Subject: Draft Environmental Impact Report, Comprehensive Groundwater Cleanup Strategy for Historical Chromium Discharges from Pacific Gas and Electric Company's Hinkley Compressor Station San Bernardino County

**Attachment 1 –Main Comment Table
Hinkley Comprehensive Groundwater Cleanup Strategy
Draft Environmental Impact Report**

**Comments of Pacific Gas and Electric Company
November 5, 2012**

Figure 2-4
Alternative 4B Conceptual Layout
(Initial Buildout to Year 20)

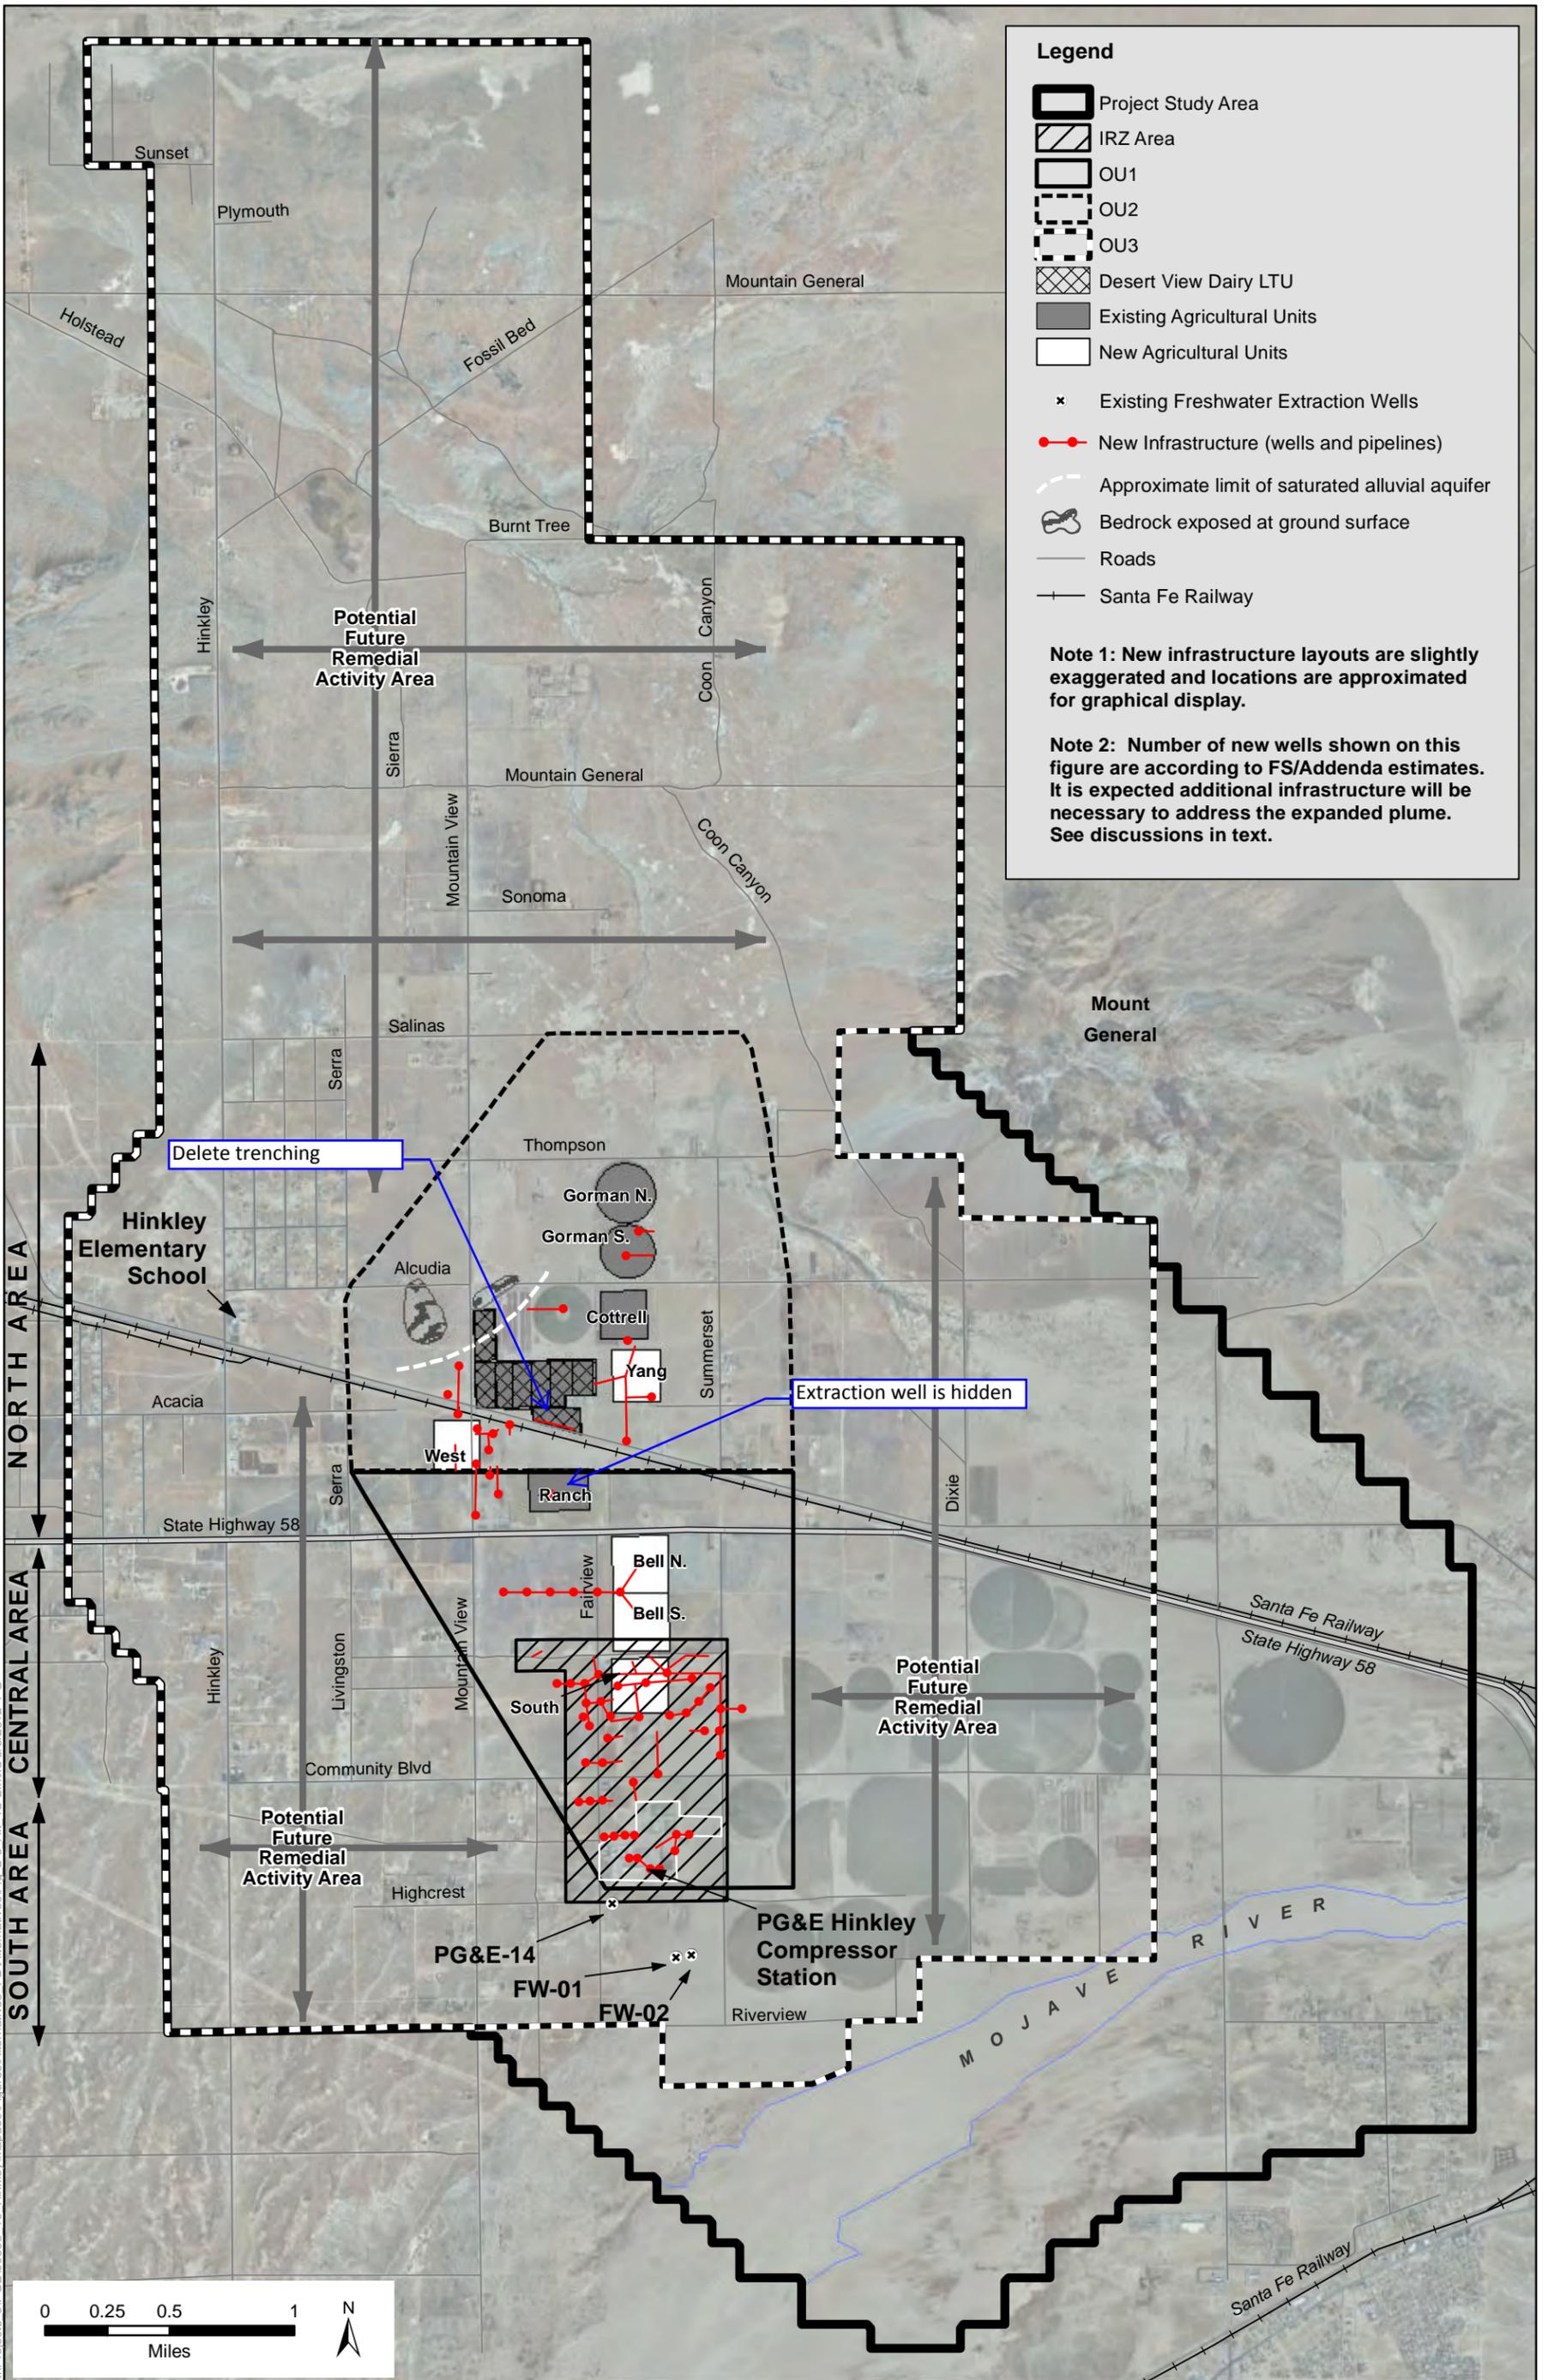
Comment [d1]: 24,499 is the linear feet of trenching, we suggest adding a note to clarify. Also applies to IRZ pipeline totals below

Figure 2-6
Alternative 4C-3 Conceptual Layout
(Initial Buildout to Year 20)

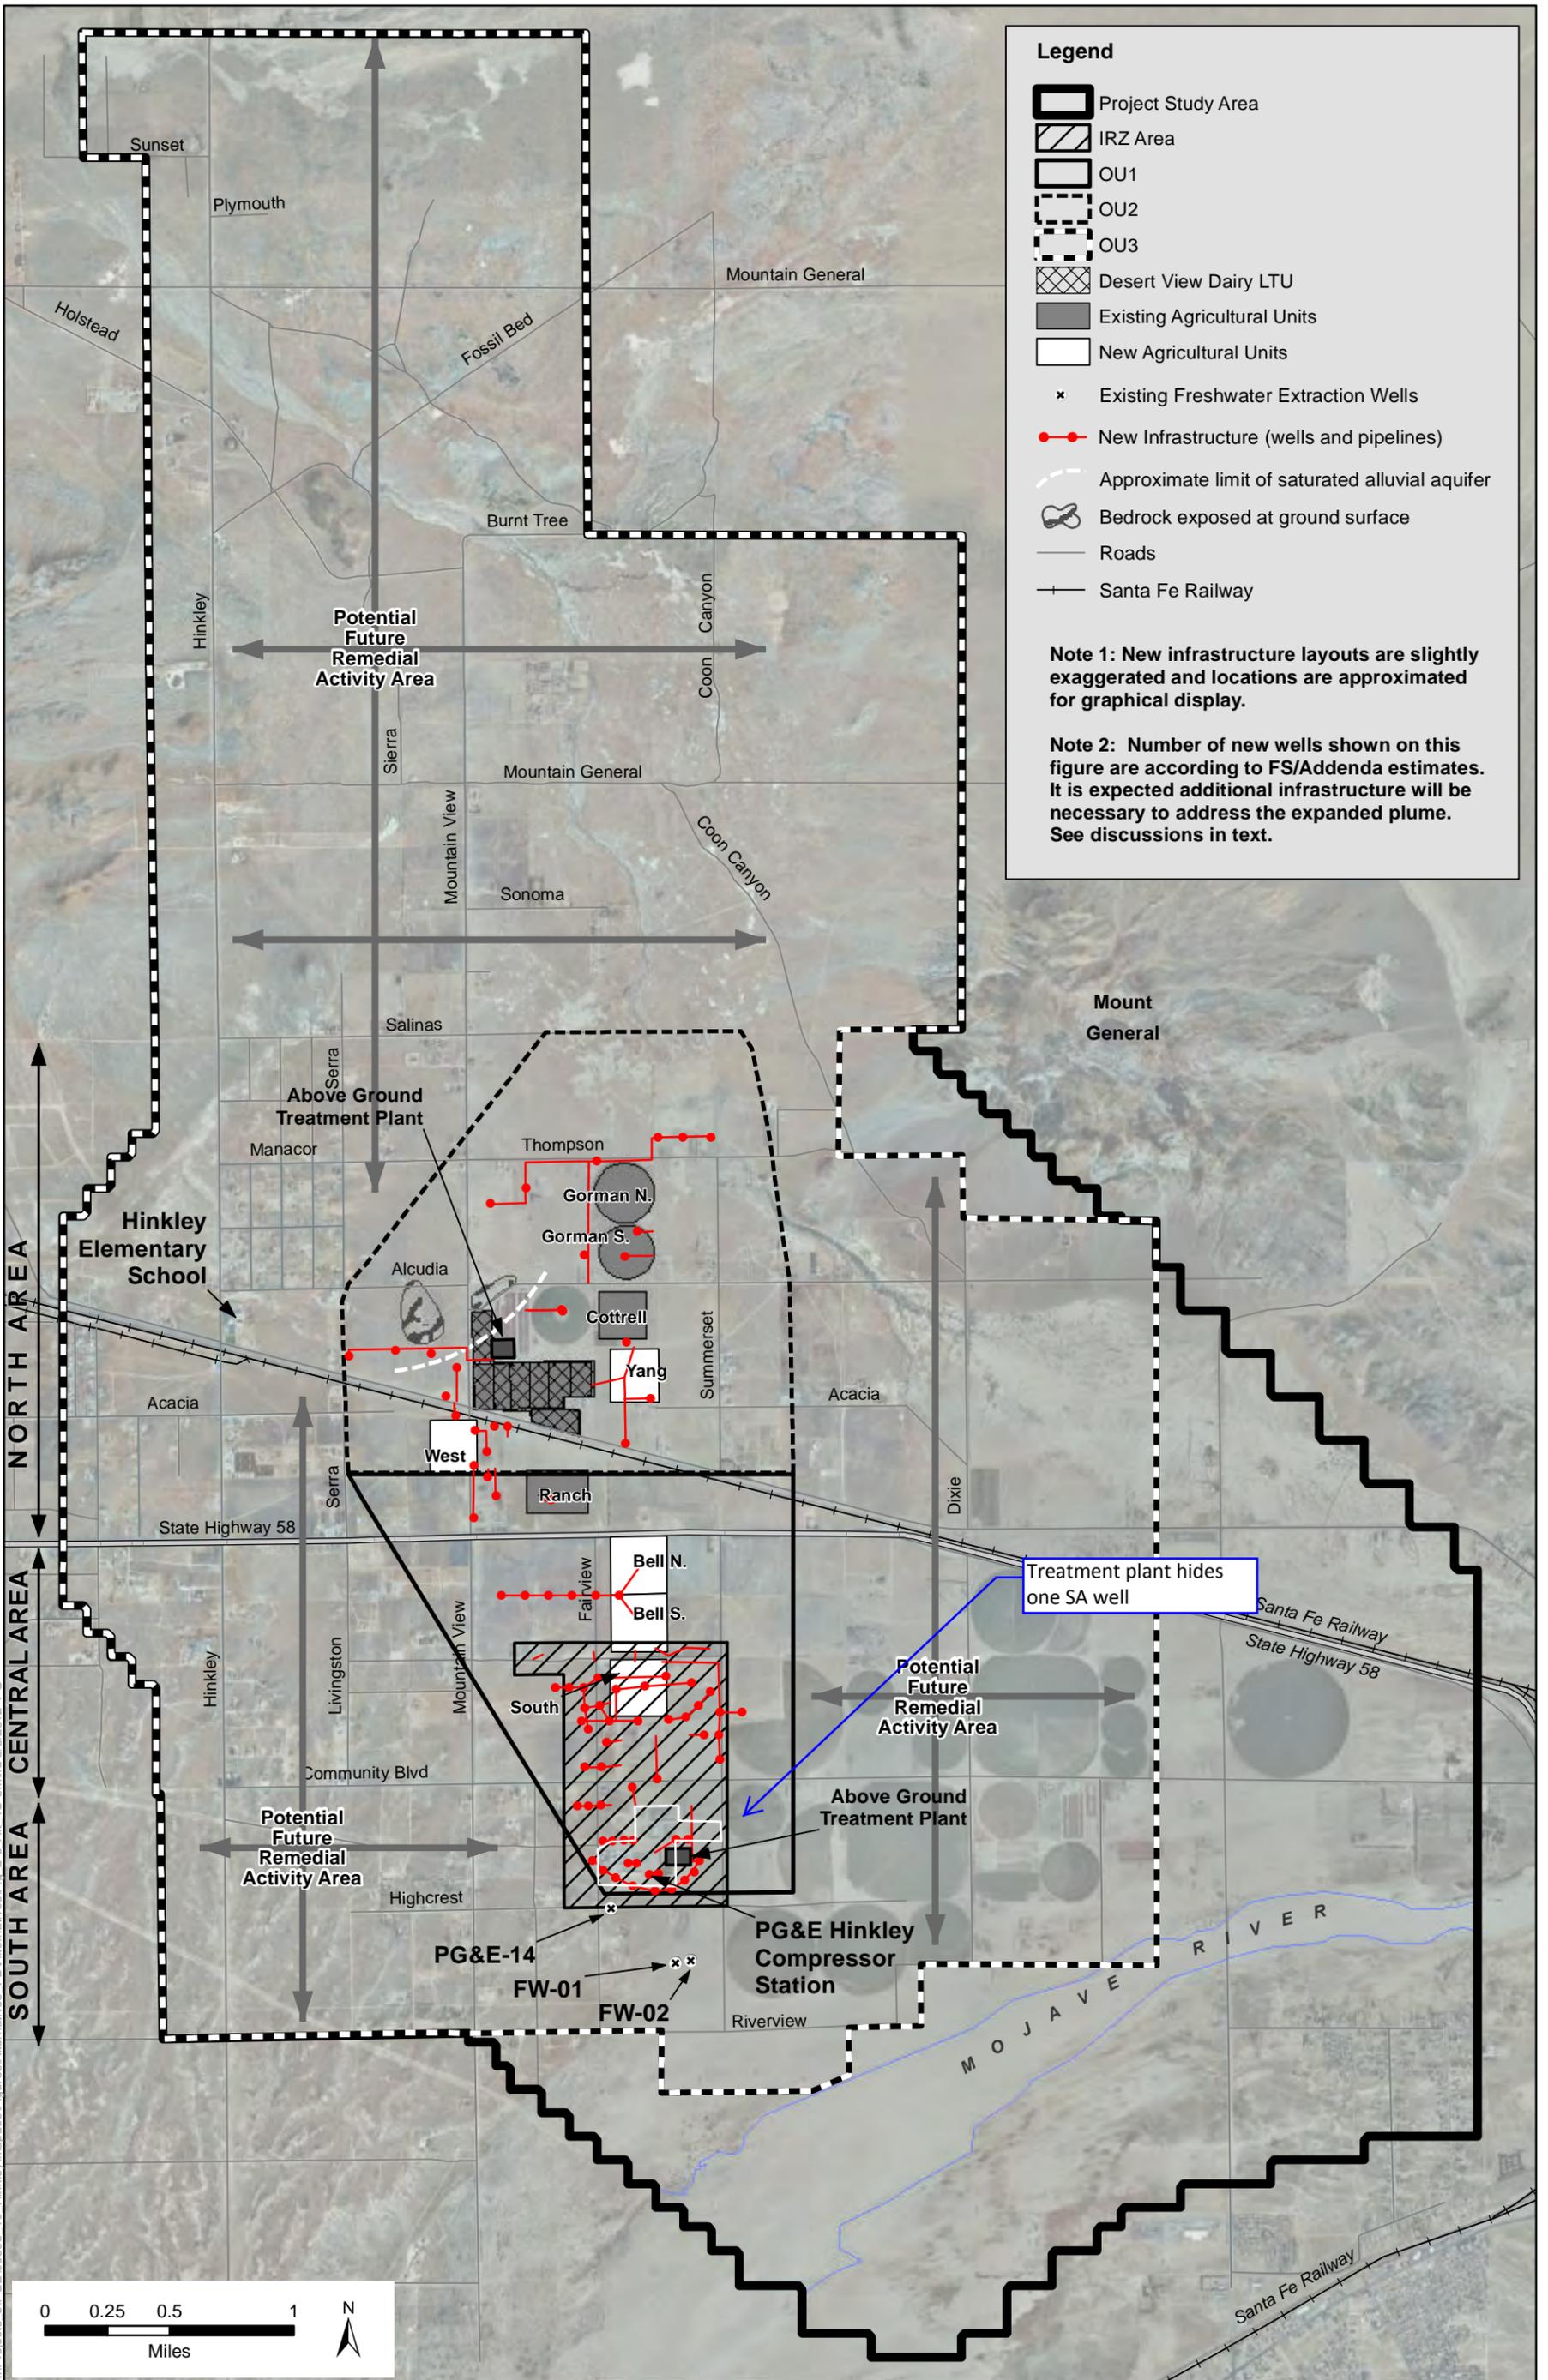
Comment [d1]: Totals are linear feet of trenching, we suggest adding a note to clarify

Comment [d2]: 140 gpm + 25% contingency

Comment [d3]: 5 + 15% contingency

Comment [d4]: Suggest clarifying that well estimates include the number of wells to be constructed; not all wells may be operating at one time

1 **Table 3.5-9. Estimated New Construction Quantities by Alternative**

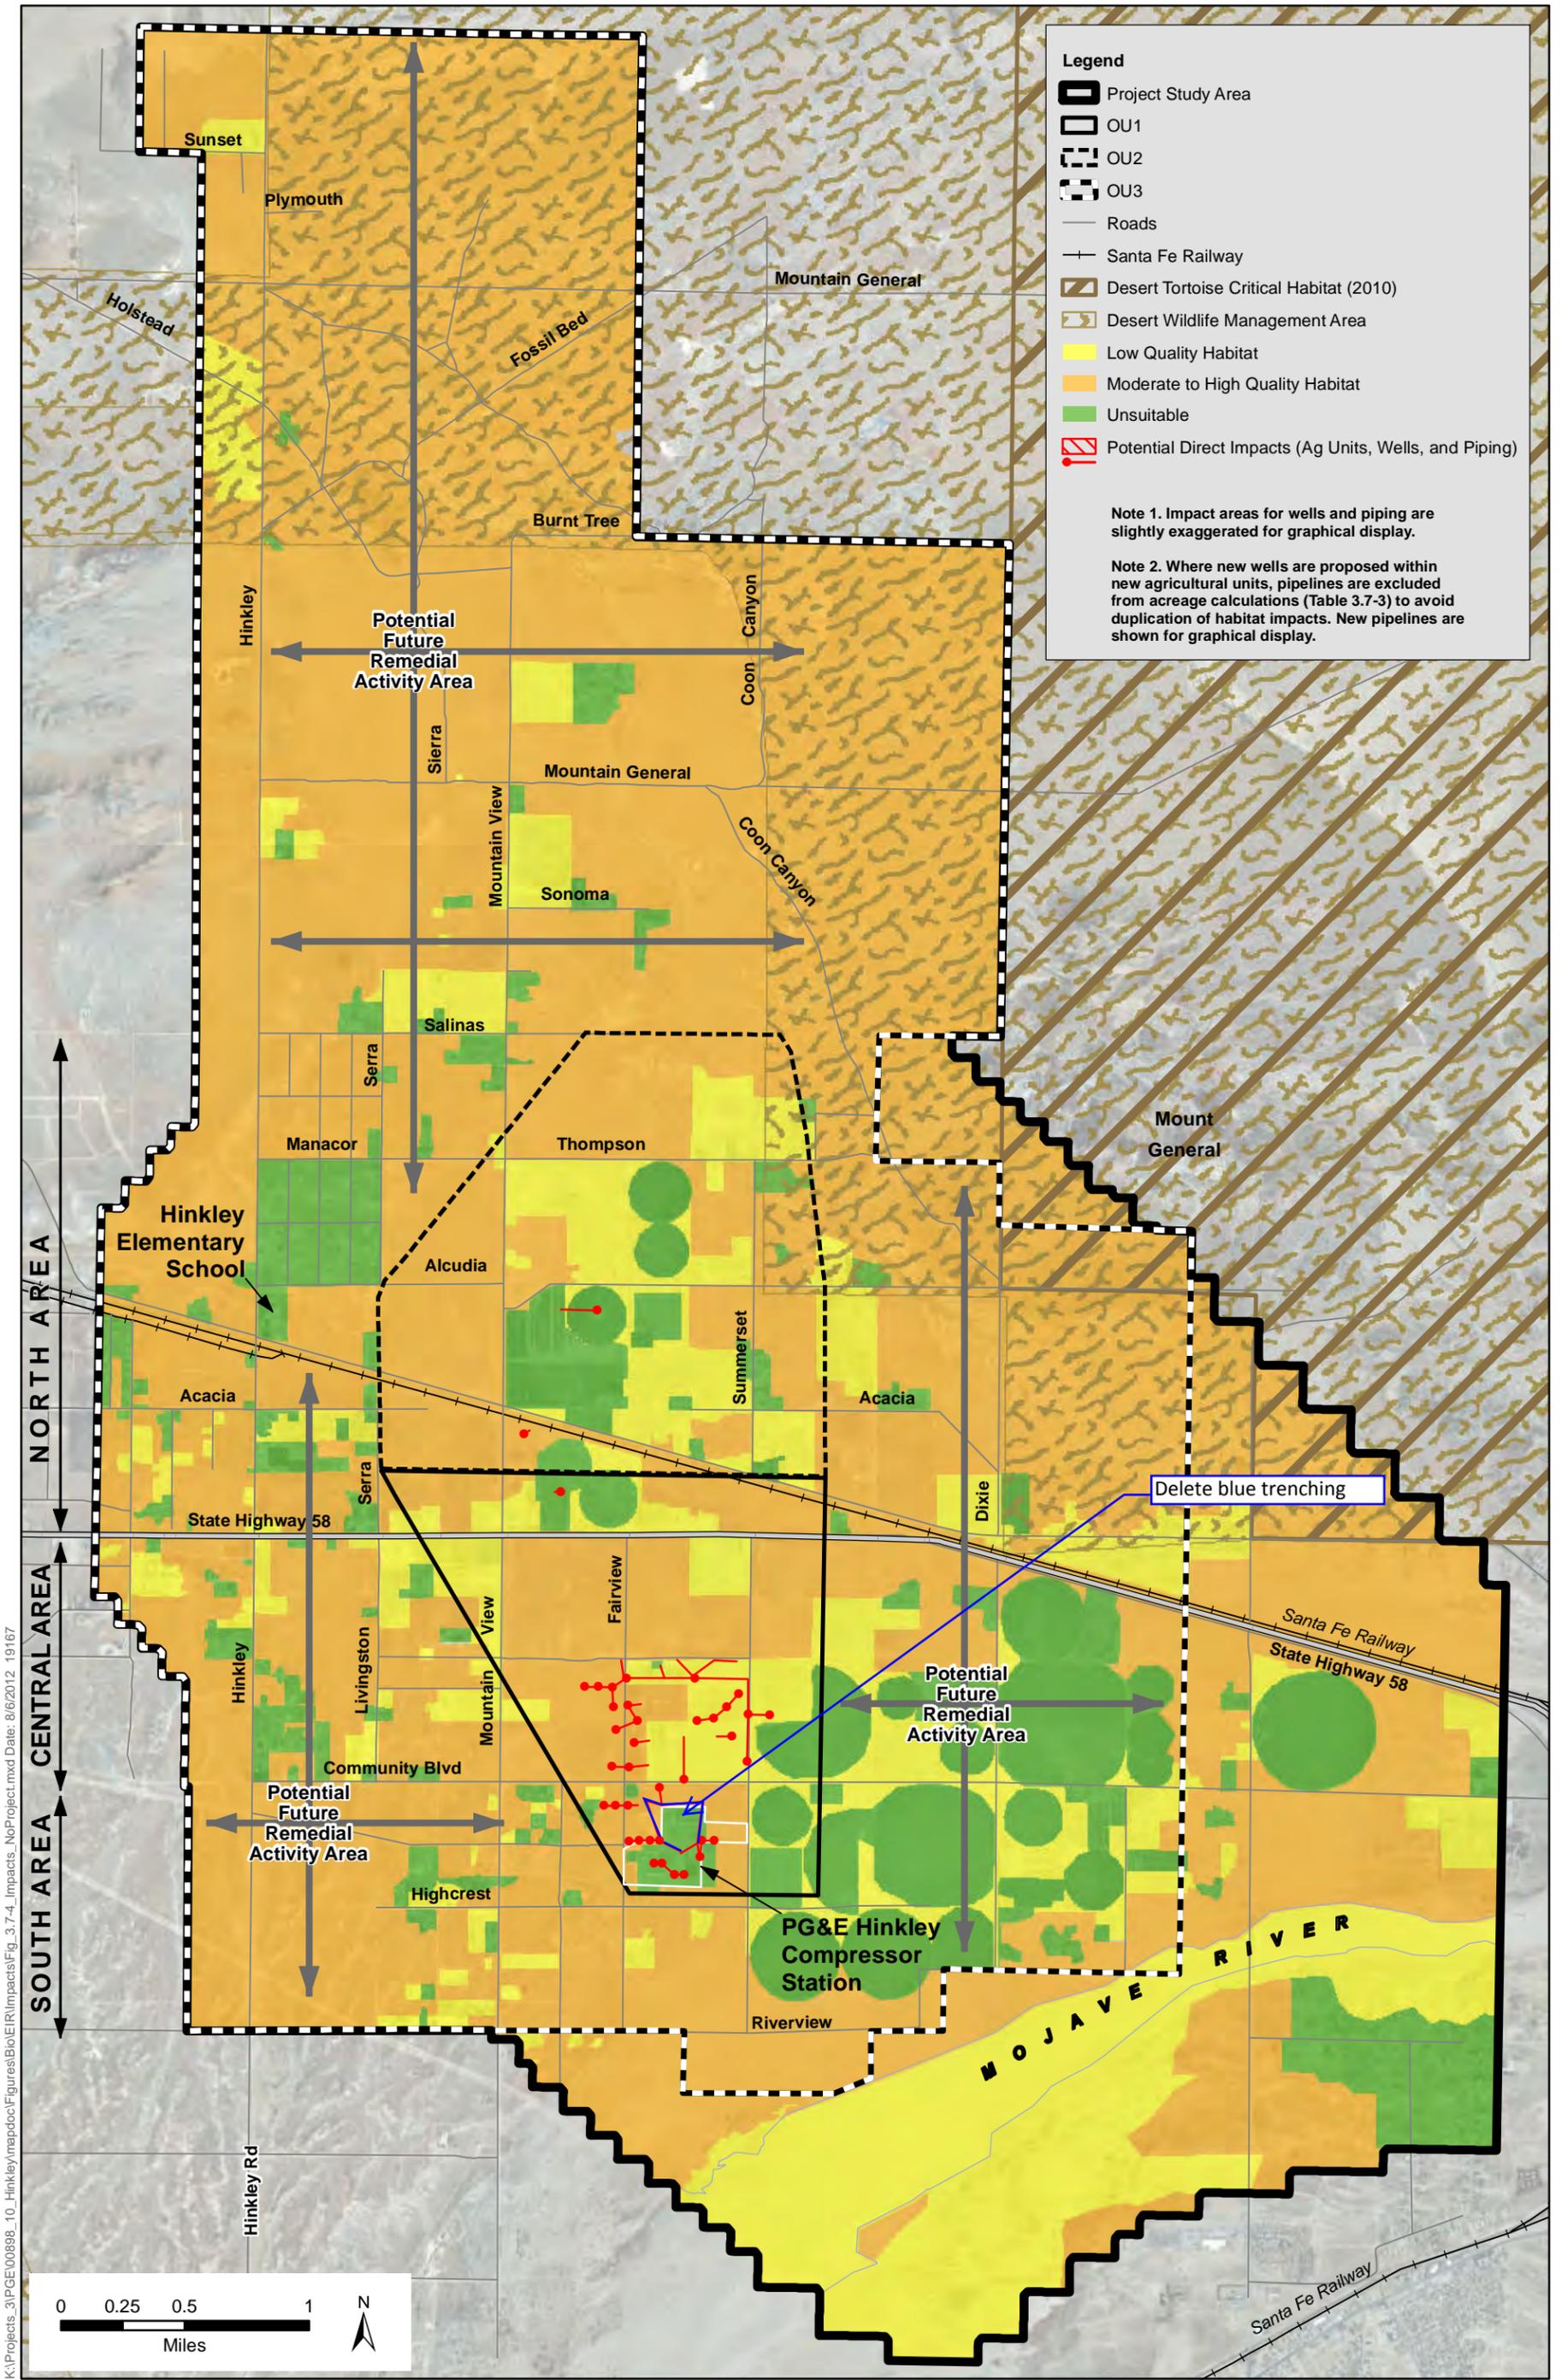
Comment [d6]: There are only a few ethanol deliveries per year

Comment [d7]: 288 miles per day which assumes 4 people for 3 shifts (12 miles each way). This number is excessive by a factor of 2 or more

Comment [d8]: 240 VMT/month, not daily

Comment [d9]: 424 VMT/month, not daily
